Access Compliance Report

Public Rights-of-Way

(Pedestrian Signals)

Intersection ID: N/A	Main Street:	Cross Street: N/A	Location: N/A
ADA ID: 64A65FA64BC3	Signal Type: Two Push Buttons-Non APS	Overall Compliance: No	Severity Score: BTN 1:N/A BTN 2: N/A No BTN: N/A
Codes/Mitigation Info/Possible Solution		Field Measurements/Component Compliance

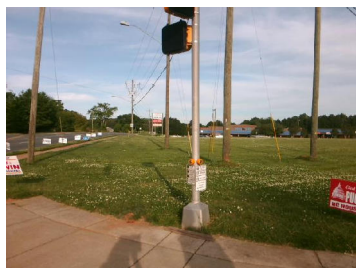
PROW/ADA: TMUTCD 4e.08, R404.7.3, R404.7.2

Compliance	Description	Data	Compliance	Description	Data
	Button Count	Button2	N/A	Distant to Additional Button (in)	N/A
	Additional Button Present?	No		Additional Button ID	N/A
N/A	Signal Buttons Required?	N/A	N/A	Additional Ped Posts Required	N/A
	How Many Ped Street Xings?	2		Located In An Island/Median?	No
N/A	B 1 Sign Present?	Yes	N/A	B 2 Sign Present?	Yes
Yes	B 1 Sign Purpose?	Yes	Yes	B 2 Sign Purpose?	Yes
Yes	B 1 Sign Lettering & Contrast?	Yes	Yes	B 2 Sign Lettering & Contrast?	Yes
Yes	B 1 Parallel To XWalk?	Yes	Yes	B 2 Parallel To XWalk?	Yes
Yes	B 1 PAR to Button?	Yes	Yes	B 2 PAR to Button?	Yes
Yes	B 1 PAR to XWalk?	Yes	Yes	B 2 PAR to XWalk?	Yes
Yes	B 1 Clear Floor Space?	Yes	Yes	B 2 Clear Floor Space?	Yes
N/A	B 1 FWD Approach?	No	N/A	B 2 FWD Approach?	No
N/A	B 1 FWD Approach Constrained?	No	N/A	B 2 FWD Approach Constrained?	N/A
N/A	B 1 FWD Approach Reach (in)	N/A	N/A	B 2 FWD Approach Reach (in)	N/A

N/A	B 1 FWD Approach Width (in)	N/A	N/A	B 2 FWD Approach Width (in)	N/A
N/A	B 1 FWD Approach Obstruction?	Yes	N/A	B 2 FWD Approach Obstruction?	Yes
N/A	B 1 FWD Approach Obstruction Dist (in)	4.0	N/A	B 2 FWD Approach ObstructionDist (in)	4.0
N/A	B 1 PARA Approach?	Yes	N/A	B 2 PARA Approach?	Yes
N/A	B 1 PARA Approach Constrained?	Yes	N/A	B 2 PARA Approach Constrained?	Yes
No	B 1 PARA Approach Reach (in)	35.0	No	B 2 PARA Approach Reach (in)	35.0
No	B 1 PARA Approach Width (in)	48.0	No	B 2 PARA Approach Width (in)	48.0
N/A	B 1 PARA Approach Obstruction?	Yes	N/A	B 2 PARA Approach Obstruction?	Yes
N/A	B 1 PARA Approach Obstruction Dist (in)	4.0	N/A	B 2 PARA Approach ObstructionDist (in)	4.0
Yes	B 1 Clear Floor Space Slope (%)	1.2	Yes	B 2 Clear Floor Space Slope (%)	1.2
Yes	B 1 Clear Floor Space XSlope (%)	1.3	Yes	B 2 Clear Floor Space XSlope (%)	1.3
N/A	B 1 PAR Slope (%)	2.1	N/A	B 2 PAR Slope (%)	2.1
Yes	B 1 Height (in)	38.0	Yes	B 2 Height (in)	32.0

Yes	B 1 Clear Xing Direction?	ClearlyMarked	N/A	B 2 Clear Xing Direction?	N/A
	B 1 Crossing Direction	To SE		B 2 Crossing Direction	To E
No	B 1 DistanceTo XWalk (in)	67.0	No	B 2 DistanceTo XWalk (in)	74.0
No	B 1 DistanceTo Curb (in)	147.0	No	B 2 DistanceTo Curb (in)	85.0
Yes	B 1 Diameter (in)	2.0	Yes	B 2 Diameter (in)	2.0

Possible Solutions: Replace Signal Push Button With APS Button on New Post. Remove & Relocate Sign.
